CURRENT TECHNICAL SPECIFICATIONS TO BE CHANGED REGARDING
REMOVAL OF REACTOR VESSEL HEAD SPRAY PORTION OF RHR
PIPING AND ASSOCIATED VALVES

JAMES A. FITZPATRICK NUCLEAR POWER PLANT
Docket No. 50-333

PROPOSED TECHNICAL SPECIFICATION CHANGES REGARDING
REMOVAL OF REACTOR VESSEL HEAD SPRAY PORTION OF RHR
PIPING AND ASSOCIATED VALVES

**SAFETY EVALUATION FOR
PROPOSED TECHNICAL SPECIFICATION CHANGE
REMOVAL OF REACTOR VESSEL HEAD SPRAY PORTION OF RHR
PIPING AND ASSOCIATED VALVES (JPTS-92-016)**

REACTOR VESSEL HEAD SPRAY SCHEMATIC

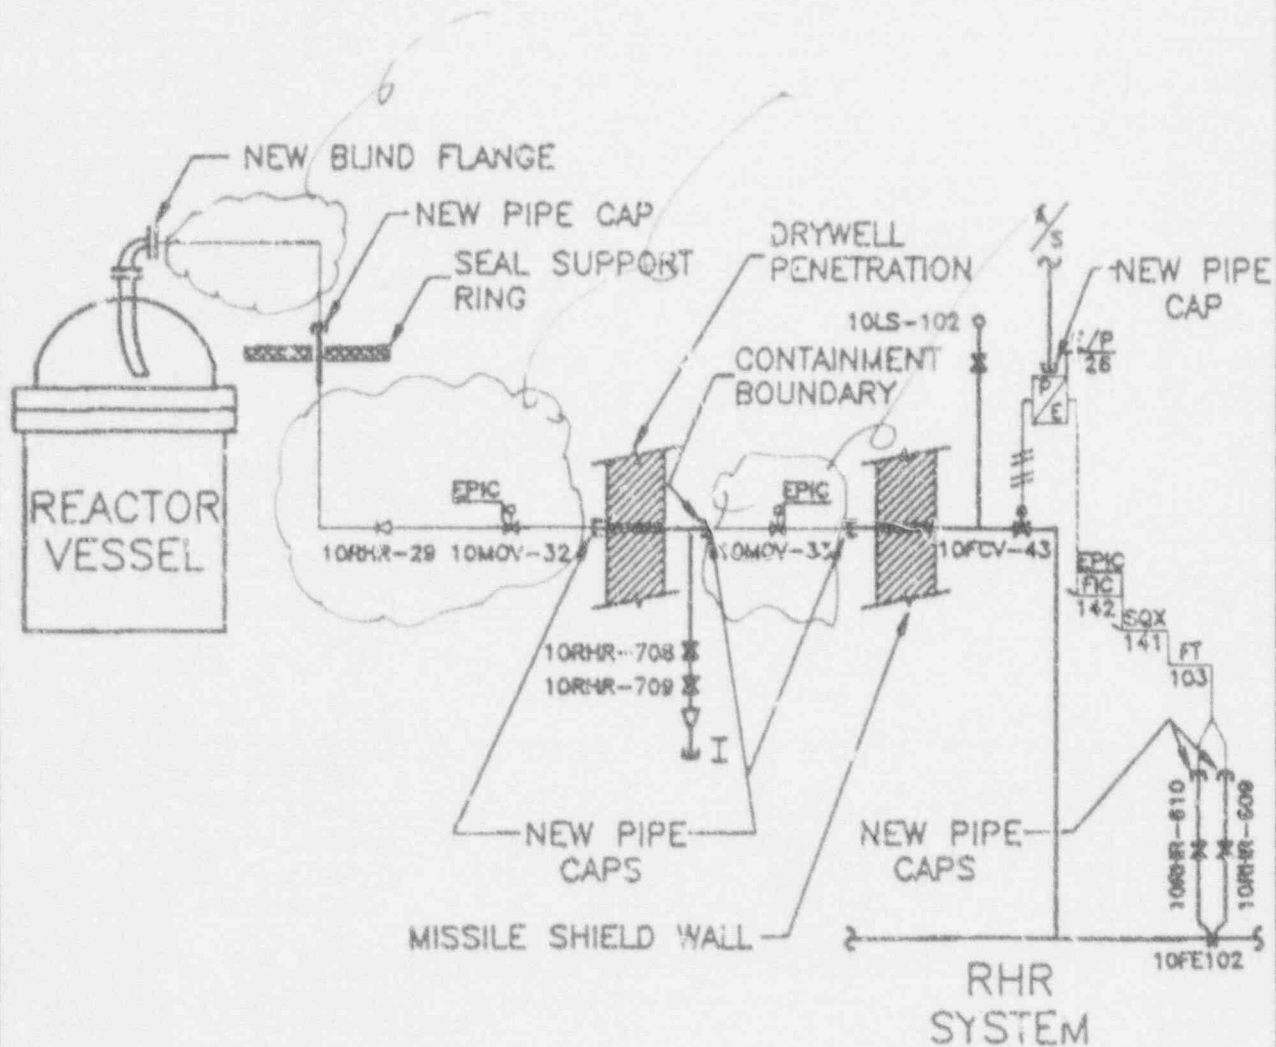
MODIFICATION TO REMOVE HEAD SPRAY

The purpose of this change is to reflect a plant modification which will deactivate the reactor vessel head spray portion of the Residual Heat Removal (RHR) System. This modification involves the removal of portions of the spray pipe and hangers from the flanged elbow attached to the spray nozzle connection on the reactor vessel head (the flanged elbow will be retained) to the west (inboard) side of the missile protective wall at elevation 336'-0". Figure 1 provides a schematic of the Reactor Vessel Head Spray System. Valves 10MOV-32, 10MOV-33 and check valve 10RHR-29 are located in the portions of pipe that will be removed. The end of the retained piping will be capped. The spray piping running through the drywell penetration thermal sleeve will be cut near both ends of the penetration, and a cap installed on each end of the pipe. This will be the primary containment boundary for this penetration. The existing LLRT connection on the pipe (including valves 10RHR-708 and 10RHR-709) located on the spray piping just outside the drywell, will be retained for use during preoperational testing of the new end caps. An ASTM blind flange will be installed on the retained flanged elbow at the reactor vessel head to ensure reactor vessel pressure integrity. All retained piping will be seismically analyzed to ensure system integrity. This modification will be completed during the 1992 Refueling Outage.

One reason for this modification is that the containment isolation valves (CIVs), 10MOV-32 and 10MOV-33 recently failed the local leak rate test (LLRT). These CIVs automatically isolate the process line which penetrates the primary containment for head spray. Head spray is an optional capability of RHR which is not used at FitzPatrick.

This modification removes the containment isolation valves 10MOV-32 and 10MOV-33 from the head spray portion of the RHR system. Since the head spray containment isolation valves will be removed, the logic system functional test for these valves will not be necessary.
